SUBJECT: Vehicle Safety Recall - SC0311
Fuel Tank Crossover Bracket

VEHICLE RECALL

SC311

Subject: Fuel Tank Crossover Bracket — CXN and CHN Model Chassis

Figure 2 — Comparison Between Crossover Support Bracket

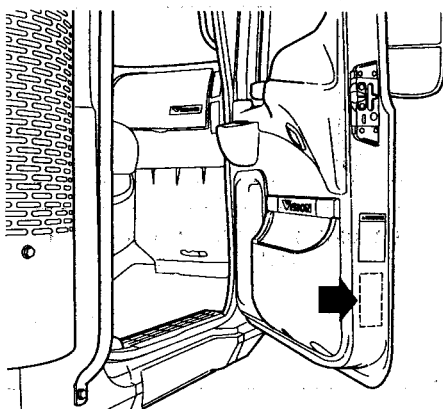
If the vehicle is equipped with a crossover support bracket having the welded mounting brackets on each end as shown in the figure below, the support bracket must be replaced with the new bracket (part No. 5MB4204M).

To replace the bracket, remove the fasteners that secure the crossover support bracket to the J-brackets on both sides of the chassis, and then install the new crossover bracket (part No. 5MB4204M). Replace the existing fasteners with new bolts (part No. 27AM3) and nuts (part No. 191AM3). DO NOT reuse the existing fasteners. Tighten the fasteners to 37 lb-ft (50 N•m).
